MIDWEST POOLED FUND PROGRAM

Progress Report - Second Quarter 2010

Midwest Roadside Safety Facility
Nebraska Transportation Center
University of Nebraska-Lincoln

Figure 8. rm43_jan07.pdf

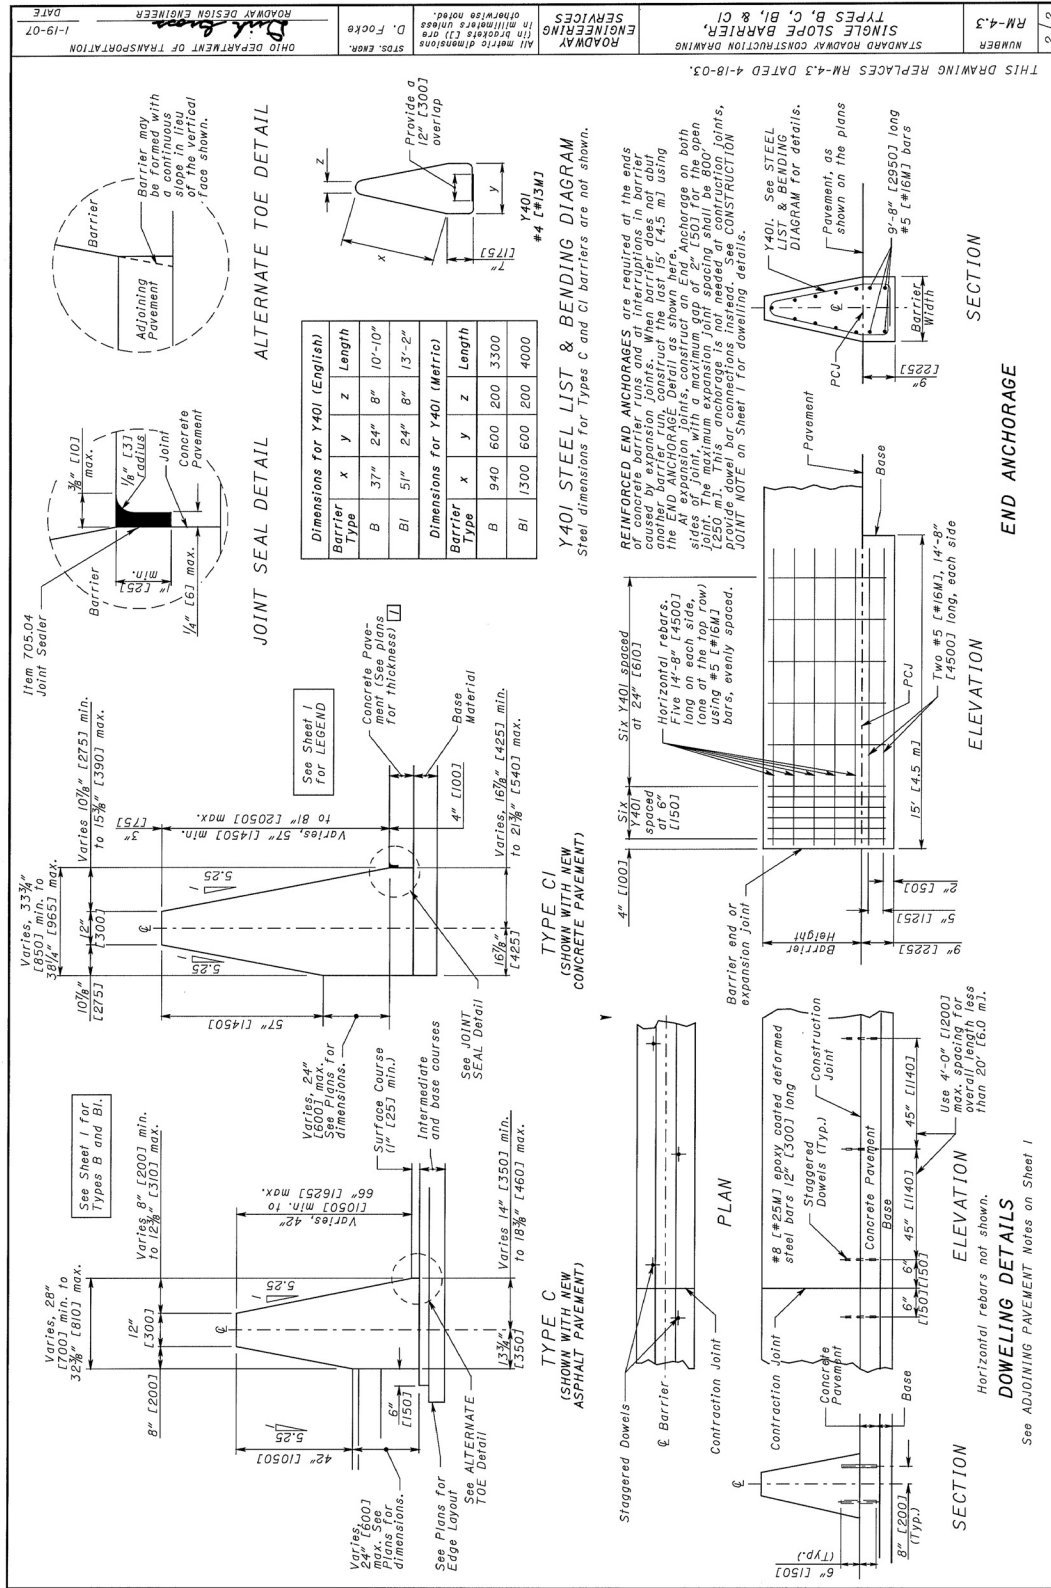
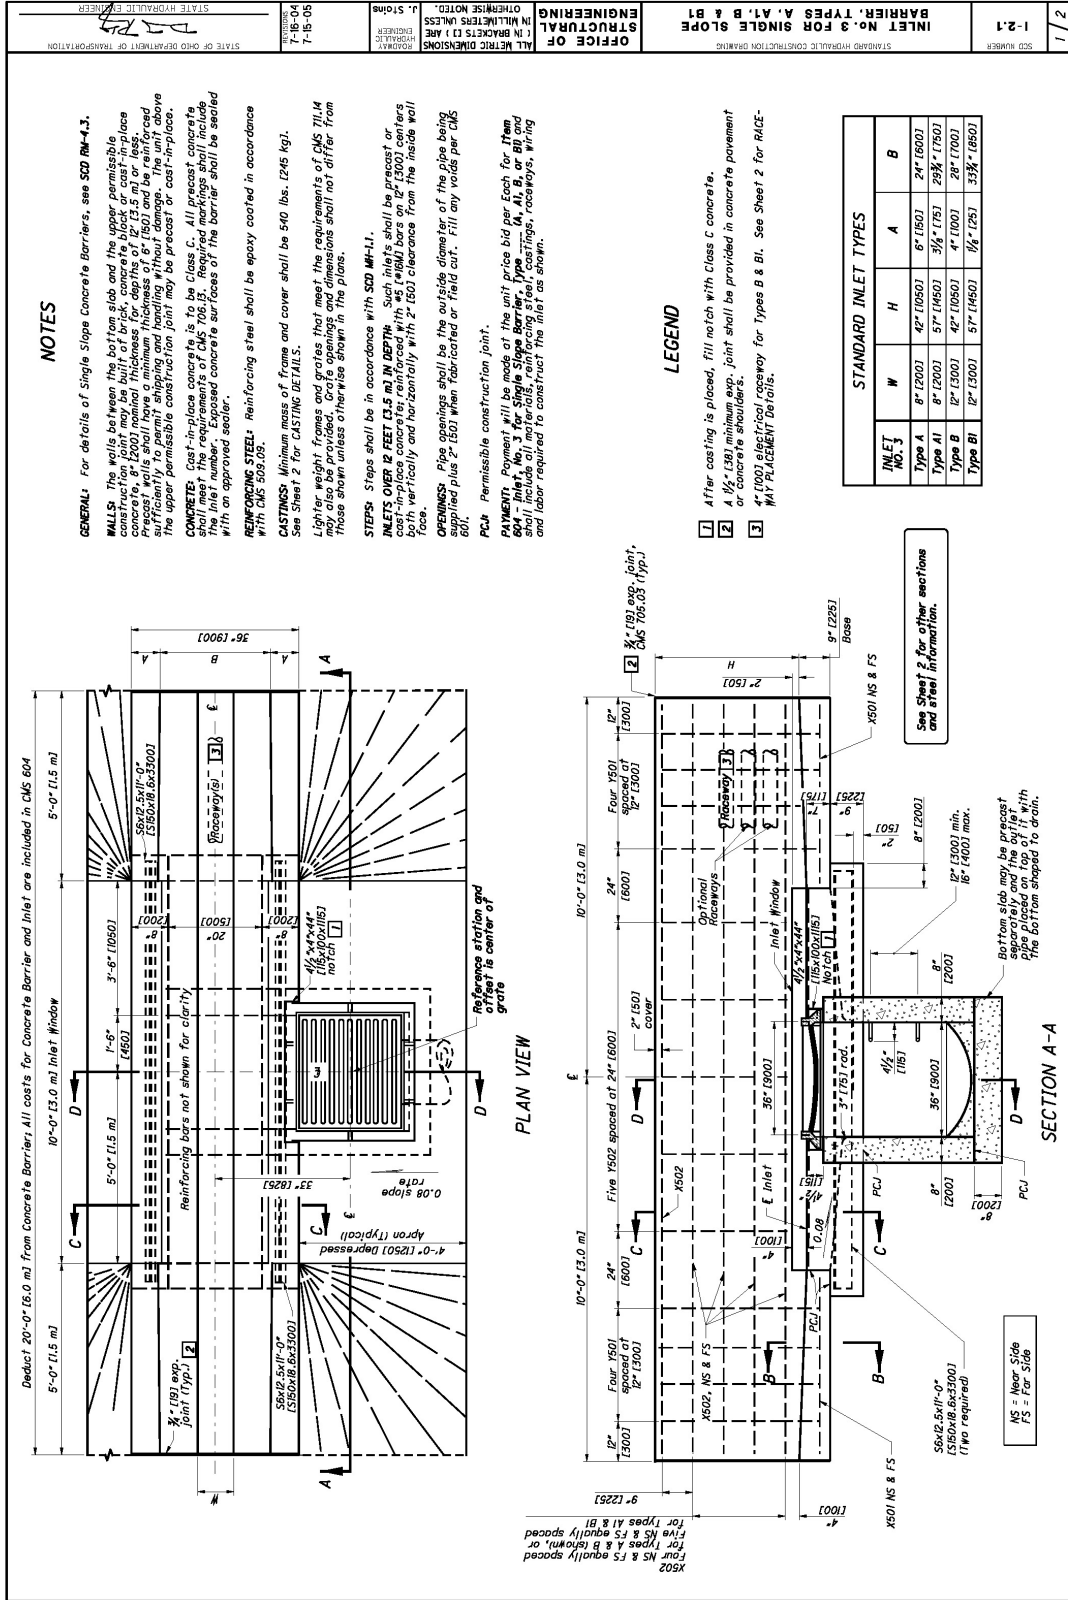
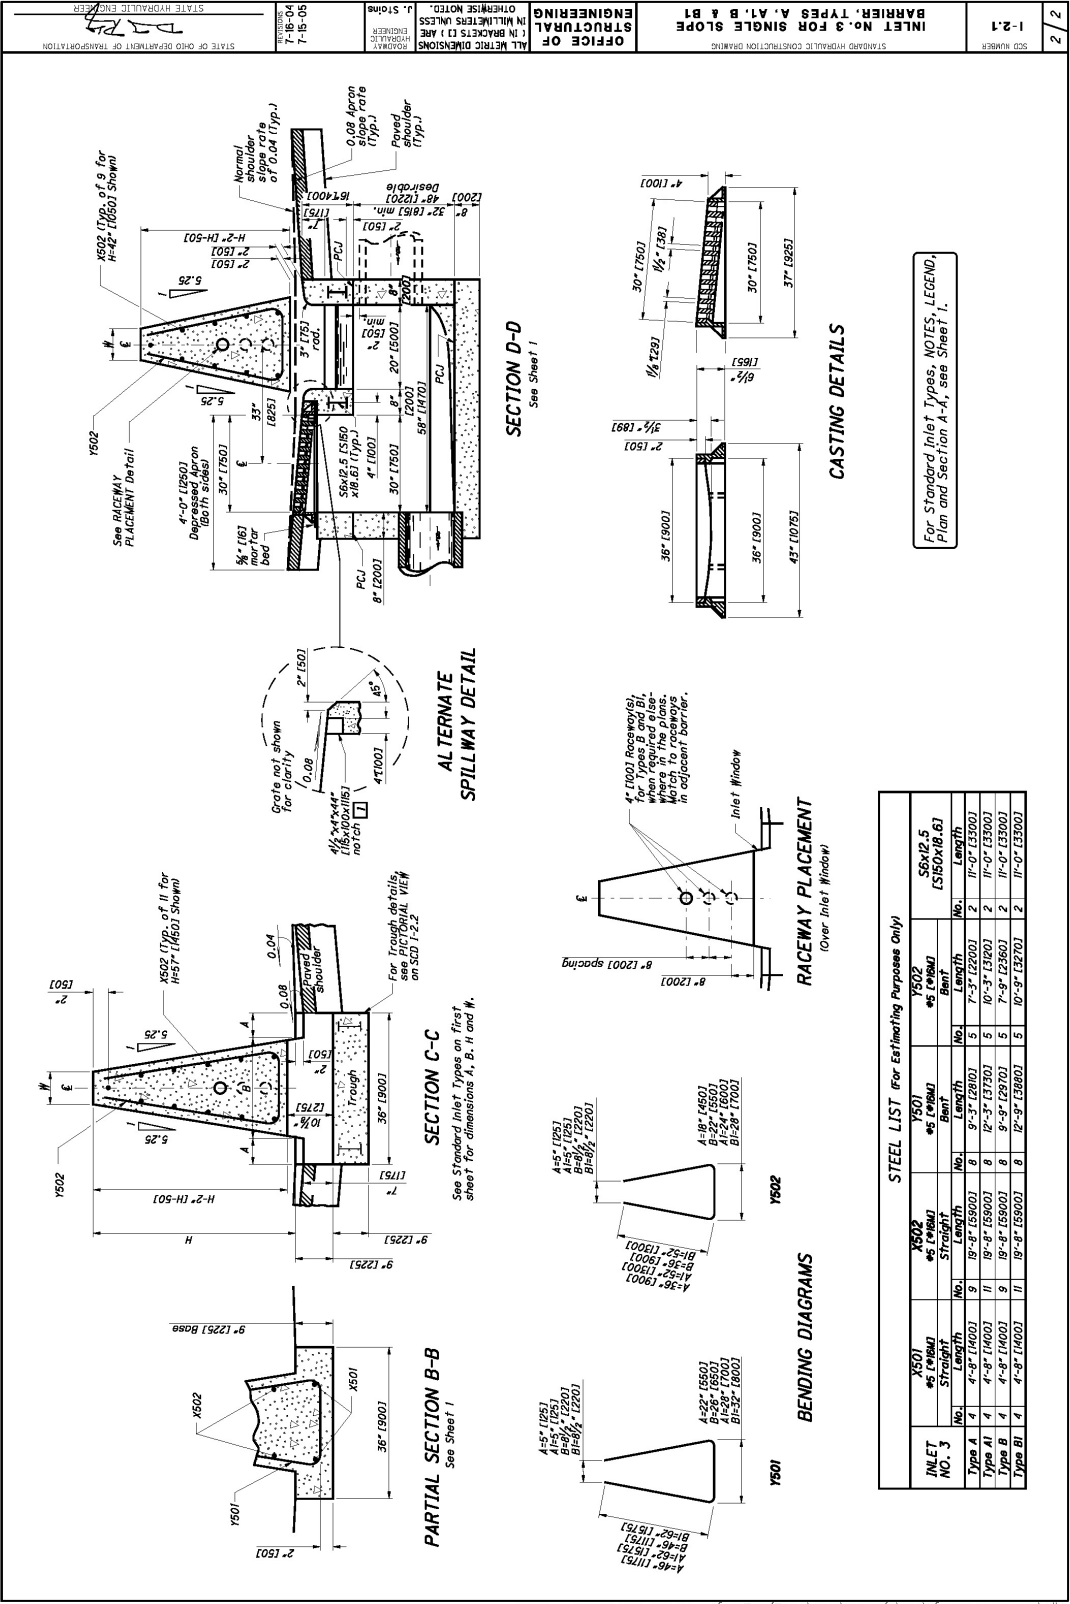
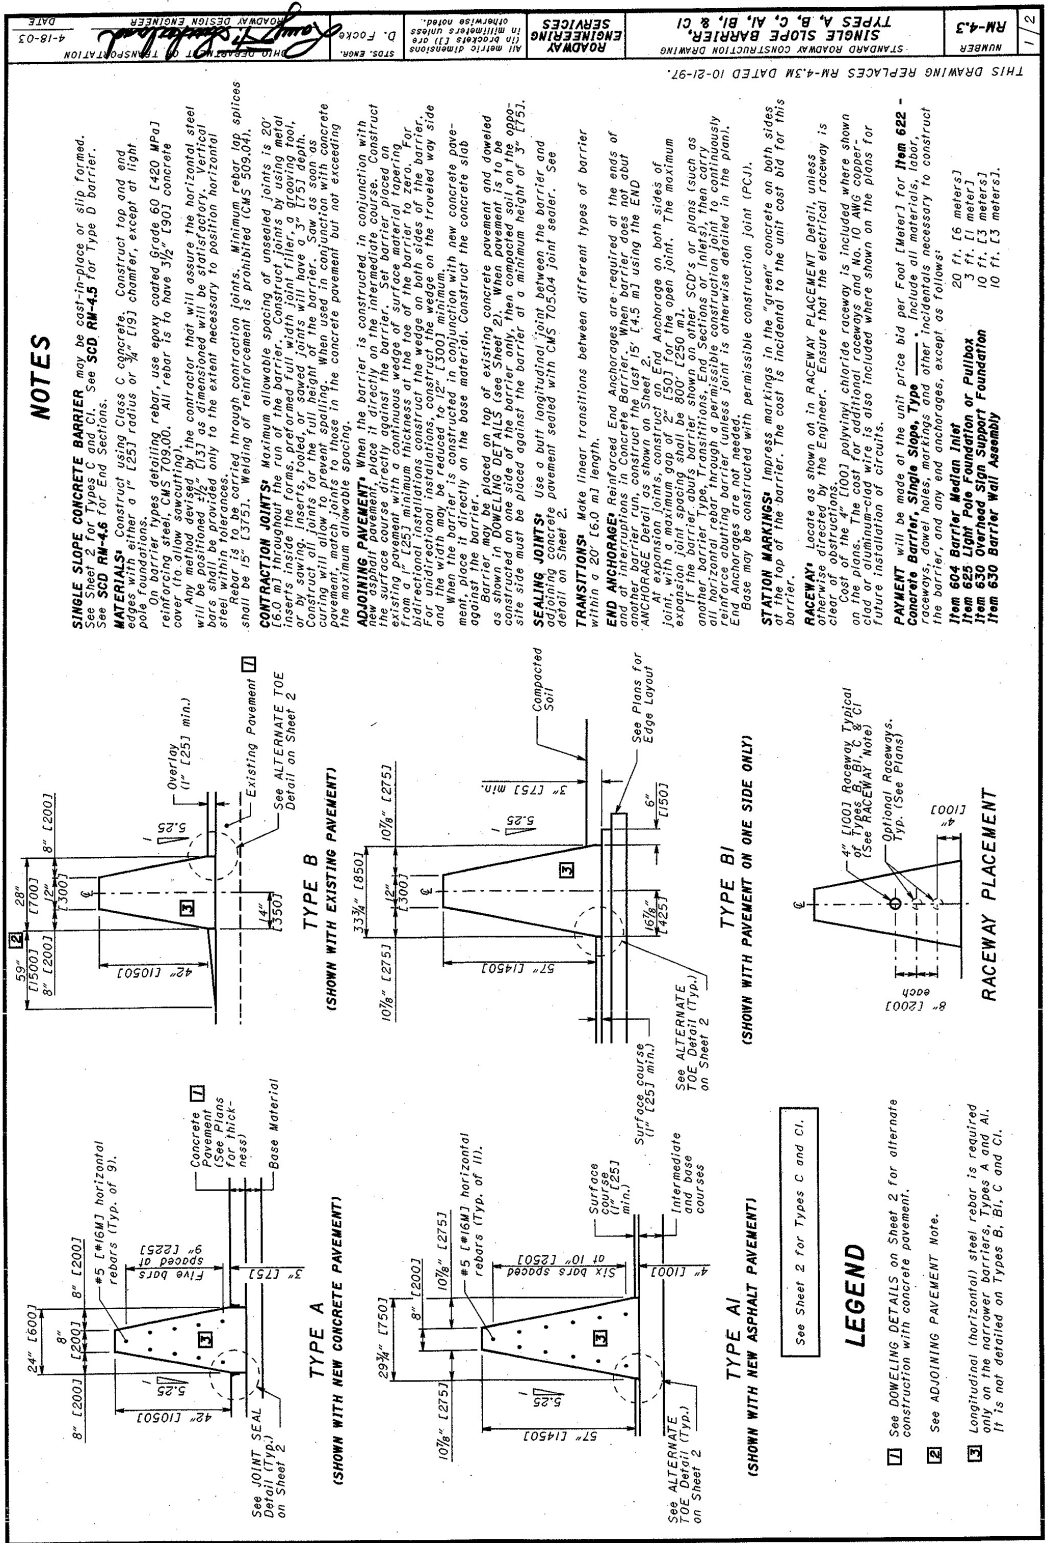
On page 2 of 2 in the pdf named rm43_jan07 there is a requirement to construct a reinforced end anchorages at all expansion joints. When the barrier wall abuts a inlet that requires a expansion joint on each end (I-2.1_jul05_v8.pdf) an end anchorage would be required on both sides. Our previous drawing rm-4.3_4-18-03.pdf did not require an reinforced end anchorage but the note on page 1 of 2 labeled End Anchorage required "all horizontal rebar through a permissible construction joint to continuously reinforce abutting barrier".

Do you have any information or testing on why this change would have been made?

**** Per detail RM-4.3, January 2007, it is clearly and correctly stated that the reinforced concrete end foundation anchorages are required when an expansion joint or gap is to be placed within the single slope barrier system or when terminating the barrier at its end. When such barrier discontinuities are used in rigid barriers, the redirective capacity of the**

barrier can be greatly reduced due to its inability to form multiple yield lines throughout the section. As a result, a common practice has been to increase the size/quantity for the vertical and longitudinal steel reinforcement at the end sections as well as to increase the embedment depth of the concrete section, such as to integrate a grade beam or footing into the end section. At expansion joints, a narrow gap is often placed completely through the entire cross section, say 2 in. Per detail RM-4.3, April 2003, the OH DOT treated expansion joints in a similar manner to that now shown in the 2007 detail. However, the length of the embedded end anchorage has increased from 10 ft in 2003 to 15 ft in 2007, which is a reasonable modification.

**** Per detail RM-4.3, April 2003, it is clearly and correctly stated that the end longitudinal steel reinforcement is to be carried across the construction joint in a continuous manner. This treatment is often handled by leaving exposed rebar segments of sufficient length out of the end of the cast-in-place or slip-formed barrier section. When the concrete construction is eventually continued, new longitudinal rebar are tied to the exposed bars and covered with concrete. Full continuity is provided at these locations when sufficient lap length is provided to ensure moment transfer across construction joint locations.**

**** In the OH DOT 2007 detail RM-4.3, it appears as though the longitudinal bars are now ended within the first concrete pour, and then 3/4-in. diameter by 18" long dowel bars are used to connect the two abutting vertical surfaces to one another. In this configuration, less than 9" of bar overlap would occur. It also may be difficult to place the dowel bars reasonable close to the existing bars and ensure continuity. The required overlap to ensure moment continuity would certainly exceed 9". If full moment continuity is expected across the construction joint, then it would be recommended to extend the longitudinal reinforcement of appropriate length through the joint. Then, the new longitudinal steel would splice to the exposed steel when the concrete placement operations were continued. If the dowel joint detail is still desired, it would be necessary to ensure that moment continuity and adequate bar development is provided across the joint.**

**** Unfortunately, I do not recall any prior discussions with Dean Focke, OH DOT regarding the change in details for the construction joints between 2003 to 2007. In addition, I am unaware of any test results regarding this issue. I went back to look at the original CALTRANS CAD details for the Type 60 family of barriers. When construction joints were shown, the footnote stated "Reinforcing steel shall extend continuous through construction joints." In addition, we assume full barrier capacity through construction joints since the steel is continuous (i.e., adequately lapped and developed) and concrete fills the gap. As such, no end anchorages and footings are needed at these construction joint locations.**
